RE: Comments To The Revised Draft Supplemental Environmental Impact Statement,
Pinedale Anticline Oil and Gas Exploration and Development Project, Sublette County,
Wyoming

**BP Comments on the Air Quality Impact Analysis Technical Support Document
For the Revised Supplemental Environmental Impact Statement
For the Pinedale Anticline Oil and Gas Exploration Project**

**Figure 1. Terrain, Measured and CALMET Modeled Wind
Roses in Southwest Wyoming**

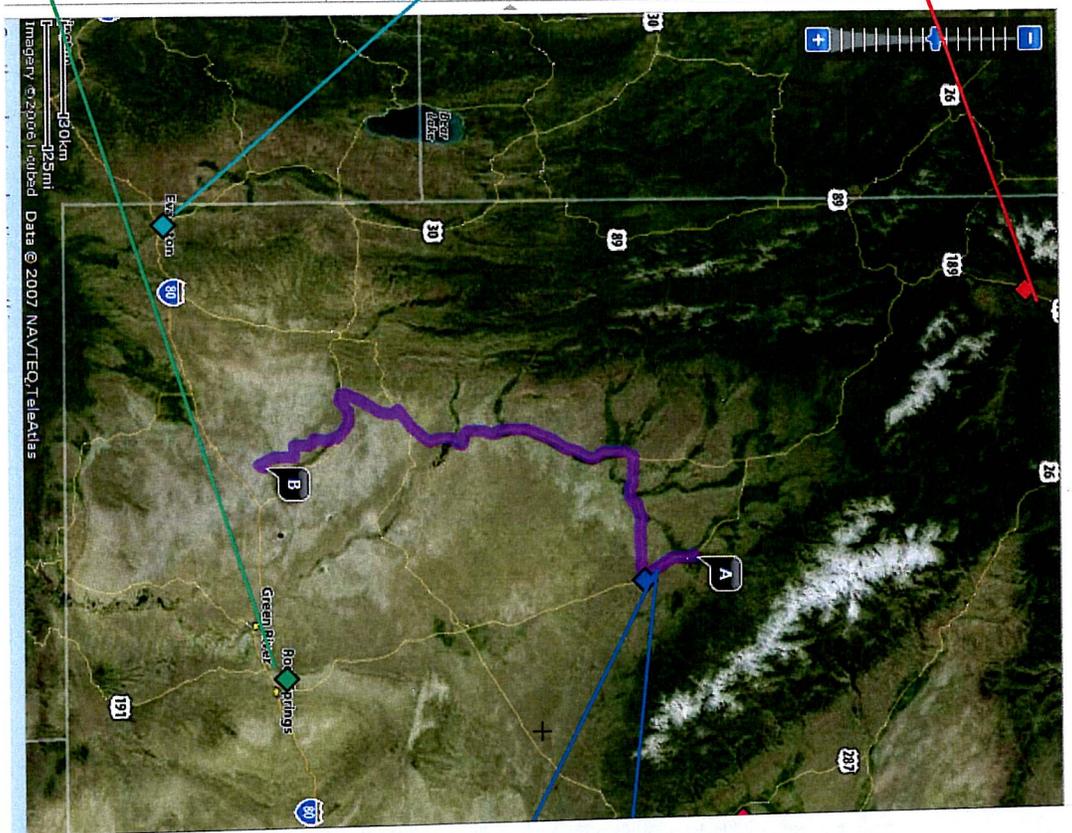
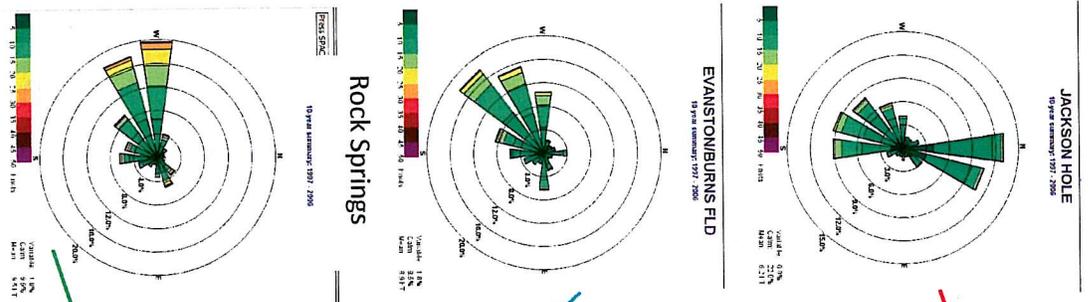
Figure 1 presents a map of the region with measured wind roses from selected meteorological towers in the region as well as a wind rose from CALMET for the Jonah tower.

CALMET uses weighting of inverse distance from grid point to surface station to determine the choice of wind speed and direction assigned to the grid cell. Figure 1 shows that for most of the direct path from Moxa Arch to the Bridger Class I Area, the Lander station is the prime influence. The topography shows that Lander is beyond the east down slope of the Bridger ridge. The representative Jonah point is before the west upslope barrier of the Bridger ridge. One important point is that the Jonah meteorological tower is located in a high desert plain and there are no terrain issues within 10 km that would locally affect winds. The Jonah observations are similar to others at Boulder, Pinedale and Daniel sites in the same valley plain.

is available from WDEQ. It is likely several other sites can be found between Rock Springs and Jonah.

To support the need for more meteorological data for the large modeling domain, the following wind fields were excerpted from <http://deq.state.wy.us/aqd/Modeling%20Studies.asp>.
(Appendix B - CALMET Wind Vector Plots for Top 10 NO2 Concentration Days)

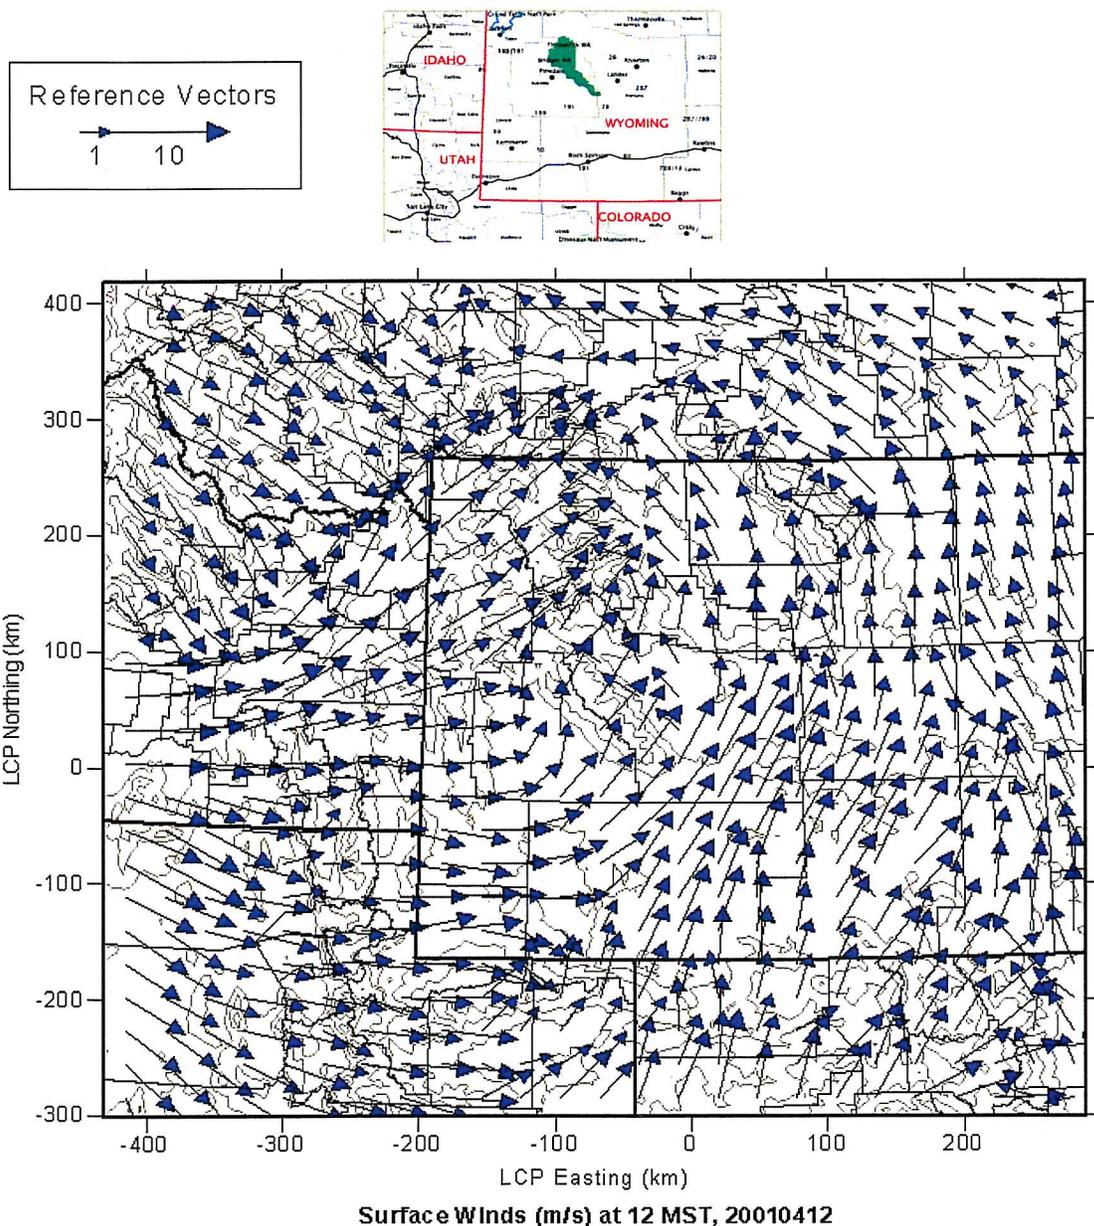
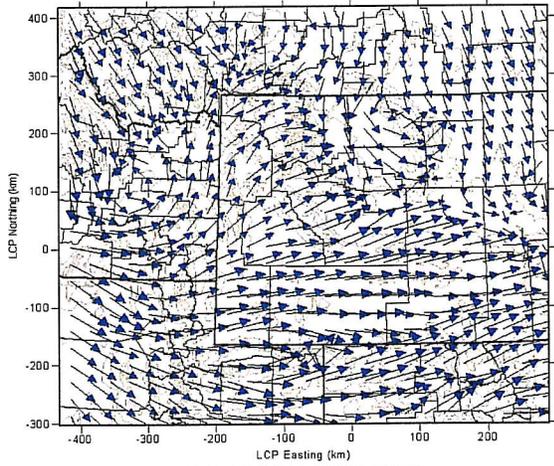
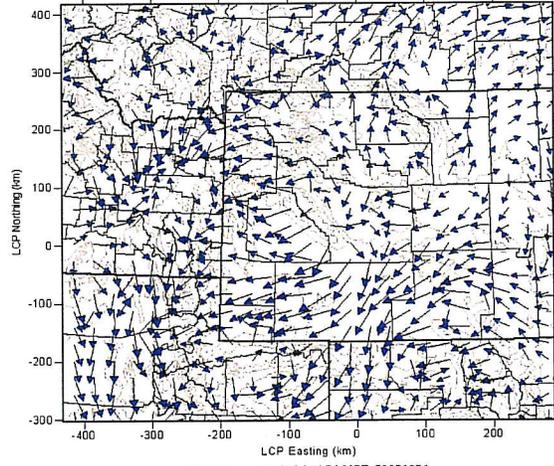
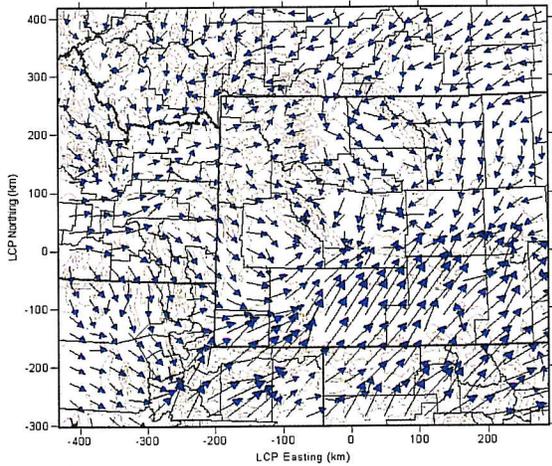
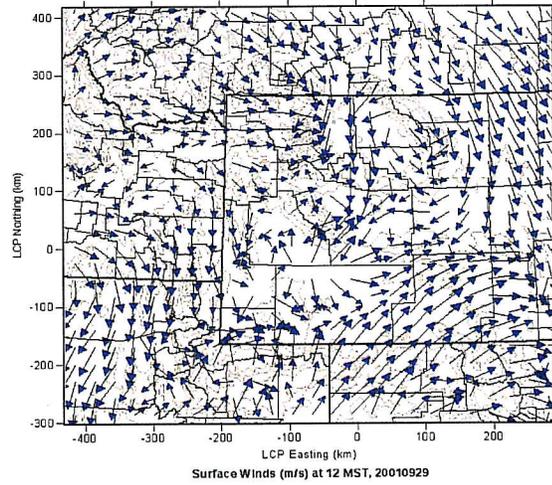
The first plot shows possible direct transport from Moxa Arch to Bridger.

The next several plots present vector flows that appear to be unrealistic of flow in the region. Each plot indicates confused flows in the Jonah plain and in the northeast quadrant that need to

be resolved by using additional meteorological stations in the meteorological modeling. It is likely that an additional surface station is needed to resolve flows in the northeast quadrant.

CALMET at Jonah grid cell 2001 – 2003

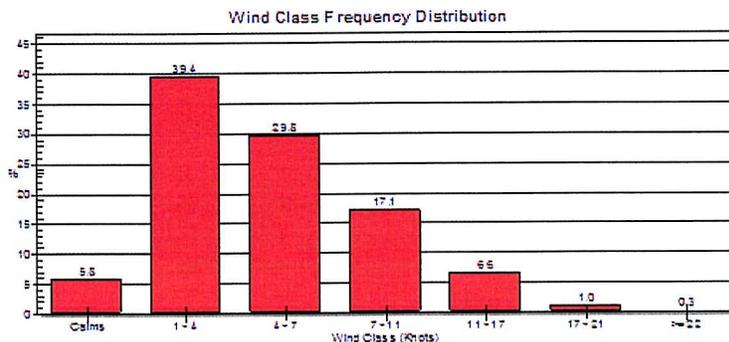
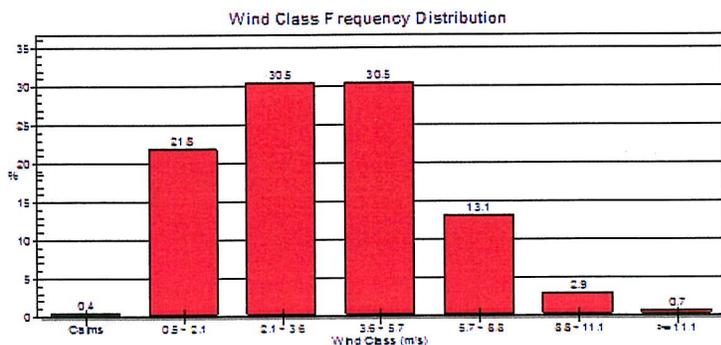
The following figures present CALMET modeled wind speed and observed wind speed at the Jonah tower. These figures indicate that the CALMET predicted wind speed is considerably lower than the observed wind speed. This finding is in addition to the predicted wind direction is not correct. The fact that the wind speed is under predicted is important because it affects the dispersion of the plume and also the rate of chemical transformation.

In conclusion, there appears to be very large uncertainty in the wind fields used by BLM in the CALMET/CAMx modeling that needs to be resolved before additional modeling is conducted. In developing a more complete evaluation of the meteorological input to the CAMx model it is recommended that as a starting point, BLM should generate wind field plots for days with predicted elevated ozone concentrations.

Figure 1. Comparison of CALPUFF Chemistry Modules

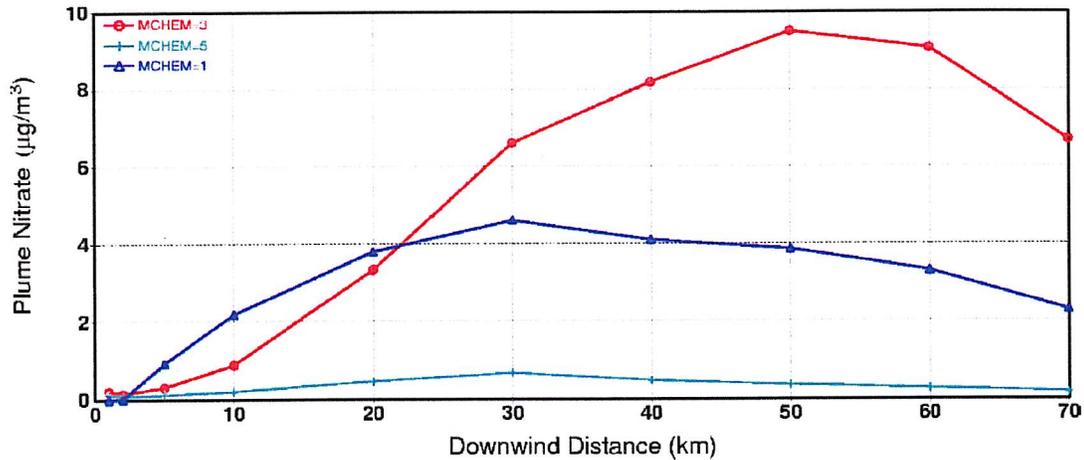
The changes to the chemistry algorithms in the CALPUFF model were revised to be more consistent with the formulation of CB4 chemical mechanisms in CAMx and CMAQ. Figure 2 presents a comparison of NO₃ predictions from the new and previous algorithms in CALPUFF. As indicated in this figure, when the model is run using current state of the art chemical formulations (consistent with CAMx and CMAQ), substantially lower NO₃ concentrations are predicted.

Figure 1. Trends in Visual Range 1988 through 2005

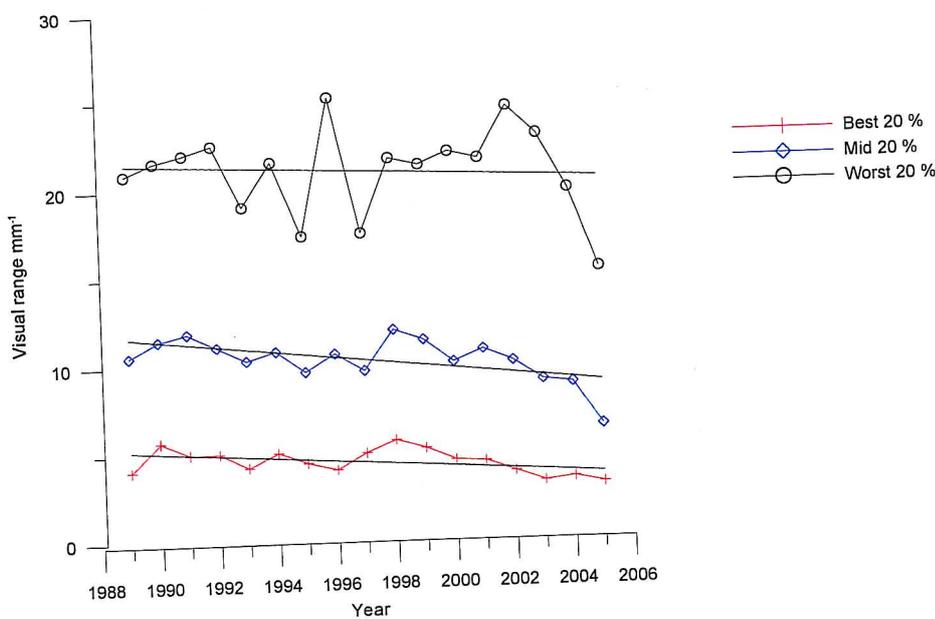
As the document stands, the 2005 baseline analysis leaves the reader with the false impression that as a result of current activities, visibility in the Bridger Class I Area (as well as other Class I Areas) is experiencing substantial degradation from oil and gas operations based on CALPUFF modeling. Conversely, the monitoring data at the Bridger Class I Area has indicated no change in visibility over the period of record (even though emissions have increased). Figure 1 presents the visibility monitoring results at Bridger over the period of record. (Note: BP calculated the statistical data for 2005 using IMPROVE equations.) This figure indicates that visibility is unchanged over the period of record, a very different impression than left by review of the modeling results. This figure presents the best, mid and worst 20 percent of the data, as expressed in inverse mega meters of degradation.

For the best 20 percent case (i.e., the cleanest days), Figure 1 indicates that there has been a slight trend toward improved visibility. The straight line represents a least square fit through the data and while there is a downward trend, the correlation coefficient is not sufficient to suggest a strong correlation. For the mid 20 percent case, the same trend is apparent as for the best 20 percent data. The trend for the worst 20 percent case appears to be relatively flat. Unfortunately, IMPROVE does not provide error bars on these data in terms of accuracy so it is impossible to identify the significance of these trends. The conclusion is that, at best, there is a slight improvement in visibility and, at worst, there has been no change over the period of record. BLM developed an actual emission inventory which was used in conjunction with 2001, 2002 and 2003 meteorology to estimate current baseline conditions. In order to correct the deficiencies with the Pinedale analysis, BLM must compare the accuracy of the modeling impacts of secondary aerosols to actual monitored secondary aerosols. An analysis using 2005 meteorology data would be the most desirable method of conducting such an analysis. However, in lieu of 2005 meteorological data, the use of maximum impacts over the period 2001 through 2003 could be used. In reality, as indicated in the BLM document, the difference in predicted impacts between years is not substantial and such an analysis using 2001 through 2003 meteorological data would provide an indication of the accuracy of CALPUFF. Because detailed information contained in the draft document is very limited, BP has attempted to conduct analyses that substantiate the need that additional model evaluations are warranted. BP requested modeling input files from TRC and those were used to perform focused analyses that demonstrate the magnitude of the potential over prediction of CALPUFF relative to monitoring data.

Figure 2. Cumulative Frequency Distribution for Bridger Class I Area NO₃ Concentrations Modeled versus Monitored 1988-2005

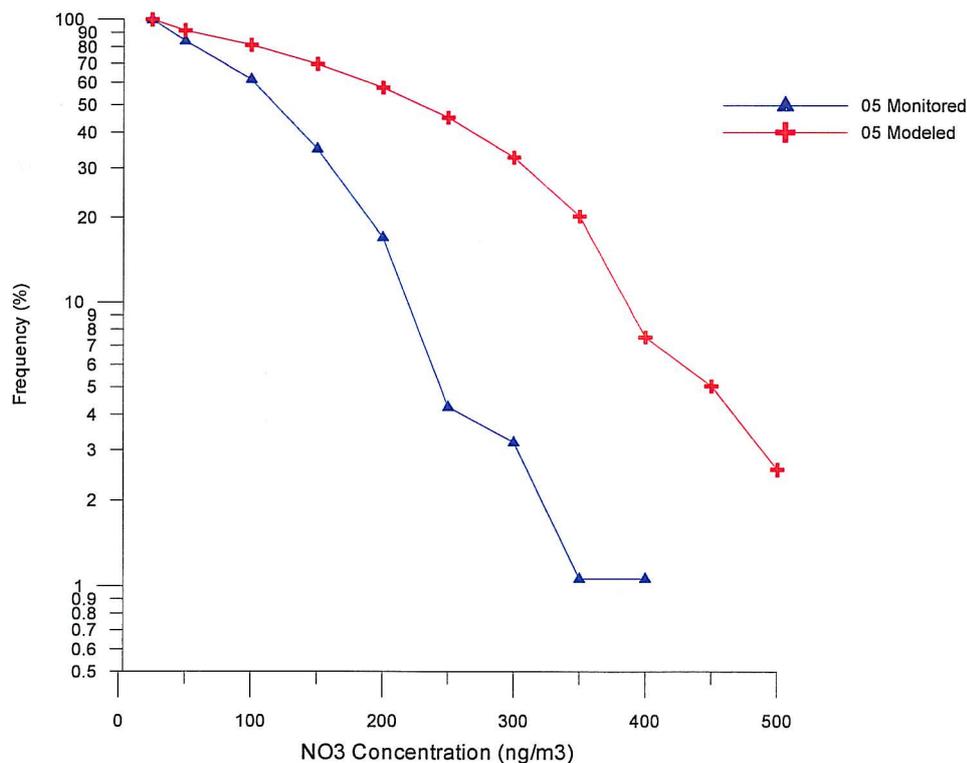
It appears that the magnitude of the CALPUFF over prediction is in the range of a factor of 6 to 35 and a model having such a magnitude of over prediction CANNOT be used to forecast future conditions. Unfortunately, BLM has chosen to ignore the recommendations previously made by BP to identify model performance and unless between draft and final a thorough model evaluation is conducted, the modeling results will mislead the public regarding potential impacts of development and will result in improper environmental management policies.

Figure 3. Cumulative Frequency Distribution for Bridger Class I Area NO₃ Concentrations 1988-2005

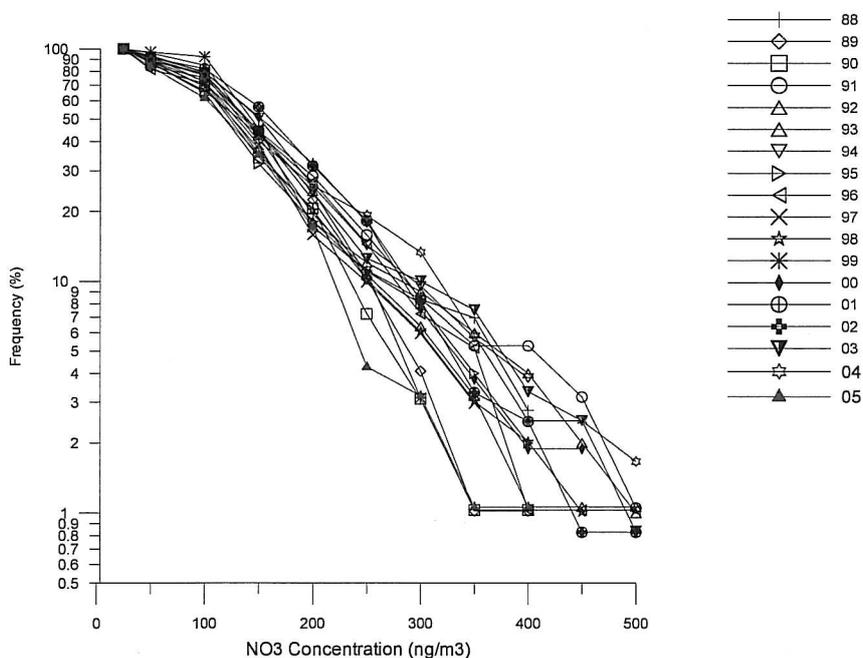
Because the above comparison focused simply on the highest predicted and measured NO₃ concentrations, care must be exercised to ensure that such a comparison is not affected by outliers. In order to address this issue, a comparison of 2005 monitored NO₃ frequency distributions was compared to the 2005 modeled frequency distribution (Figure 2). This figure demonstrates that the NO₃ frequency distribution for the monitoring data is substantially lower than the NO₃ frequency distribution for the modeling results. This

again indicates that CALPUFF is not accurately replicating observed concentrations. The fact that the CALPUFF model is not replicating any portion of the frequency distribution is a very strong indication that the any differences between monitor location and maximum receptor or sampling interval are not significant, but rather inaccuracy in the model formulation and application. Figure 3 presents the frequency distribution for all measured NO₃ concentrations over the period or record (1988 through 2005) and demonstrates that the frequency distributions for all years of monitoring data are similar. This clearly illustrates that 2005 monitoring data are consistent with measurements made during other years.

It should be stressed that the 2005 actual emission inventory only includes oil and gas operations from the Pinedale Study Area. Emissions from oil and gas operations beyond the Pinedale Study Area, emissions from non oil and gas industrial sources (trona and power production), mobile sources, residential emissions, etc. are not included in inventory. If these additional emissions were included in the modeling analysis as they are in the monitoring data, modeled NO₃ concentrations would become larger, thus further increasing the amount of model over prediction compared to monitored impacts.

Figure 4. Predicted and Observed NO₃ Levels

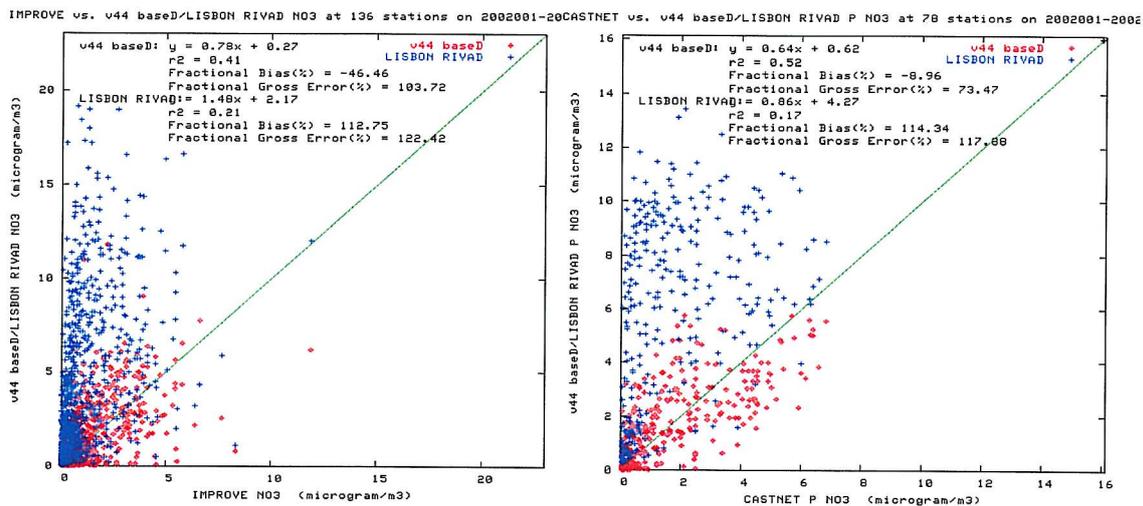
As part of the Environ paper, comparisons of NO₃ formation using the MESOPUFF II chemistry module in CALPUFF were compared to the IMPROVE and CASTNet monitoring data and Figure 4 present these comparisons. The blue points represent the MESOPUFF II predictions and the red points represent model predictions from CMAQ (a current state of the art photochemical model). As indicated in these figures, the MESOPUFF II chemistry module overstates NO₃ formation where the CMAQ model, using a complete chemical module, correlates better with the observations.

Based on information provided in the Pinedale analysis, it is inappropriate for BLM to issue a Record of Decision (ROD) for development that includes additional mitigation that is predicated on the draft CALPUFF analysis without supporting evidence that the model is accurately predicting concentrations and changes in visibility.

Comparison of NO₃ Predicted Concentrations for Various NH₃ Levels As a Function of Distance

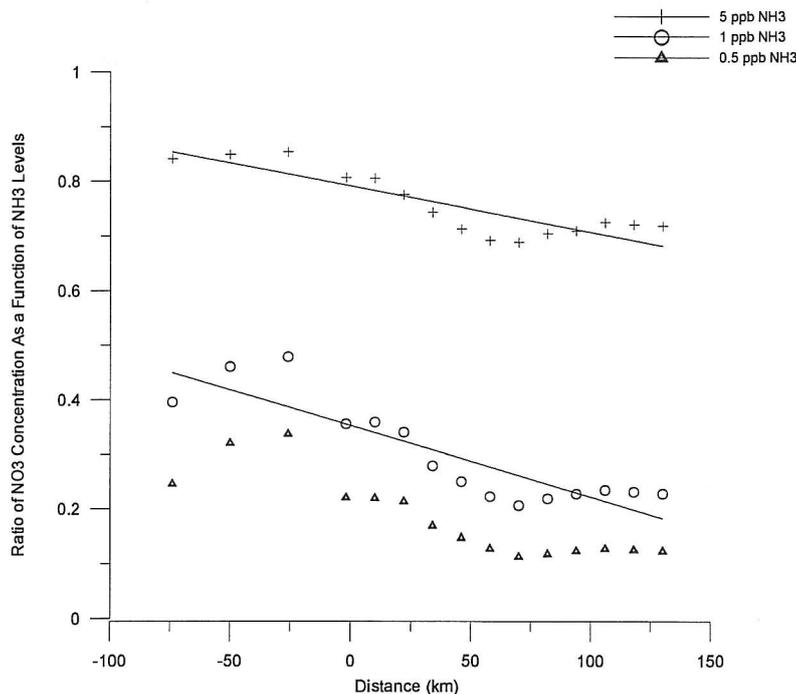
A potential reason that CALPUFF is over predicting observed NO₃ concentrations is the assumed use of the IWAQM default NH₃ concentration of 1 ppb. This assumption is in direct conflict with the modeling analysis that was done for the South West Wyoming Technical Air Forum (SWWYTAF). One major finding of the SWWYTAF modeling verification analysis was that CALPUFF would not replicate observed NO₃ concentrations in the Bridger Class I Area using the IWAQM default NH₃ concentrations. An extensive analysis of air quality measurements in the region concluded that NO₃ formation was limited by NH₃ concentrations. Once this finding was included in the modeling along with boundary conditions, CALPUFF replicated the observed NO₃ concentrations. In the Pinedale EIS analysis, ignoring this finding and using an arbitrary default value adds unnecessary conservatism to the analysis. Figure 5 illustrates the effect on predicted NO₃ concentrations based on background NH₃ concentrations.

As indicated by this figure, there was approximately a 60 percent difference in predicted NO₃ concentrations by changing the background concentration from 1 ppb to 0.5 ppb. The application of how NH₃ concentrations are used in CALPUFF is very conservative because the model assumes that the NH₃ concentration is uniform between the ground and plume height. In reality, this assumption is not likely to be true and NH₃ concentrations at plume height will be less than those at ground level.
